Service Advisory

Solara 3G High-Arm Option Limits Seat Cushion Width

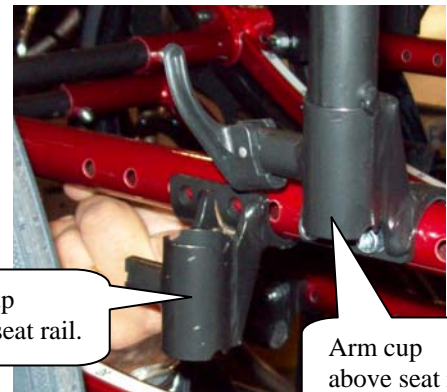
Problem Detail: When the High-Arm option is selected on the Solara 3G wheelchair, the front arm mounting cups will interfere with a Pindot ContourU seat pan, or any other seat that has the full specified chair width.

If the High-Arm option causes the front mounting hardware to interfere with seat pan / seat cushion mounting, the chair will need to be changed to the Standard-Arm configuration. This will reduce the maximum arm rest height by 2 ¼ inches.

Solution: The Standard-Arm and High-Arm options are provided using the same mounting hardware. For the High-Arm option, the brackets are mounted with the cups above the chair seat rail. For the Standard-Arm option, the hardware is mounted with the cups below the seat rail.

Changing the Configuration: To change from the High-Arm configuration to the standard configuration:

- Remove the two front arm cup brackets.
- Install the bracket taken from the right side on the left side of the chair, with the cup oriented below the seat rail.
- Install the bracket taken from the left side on the right side of the chair.
- Repeat the procedure of trading left and right brackets on the two rear arm brackets, mounting the cups below the seat rails.
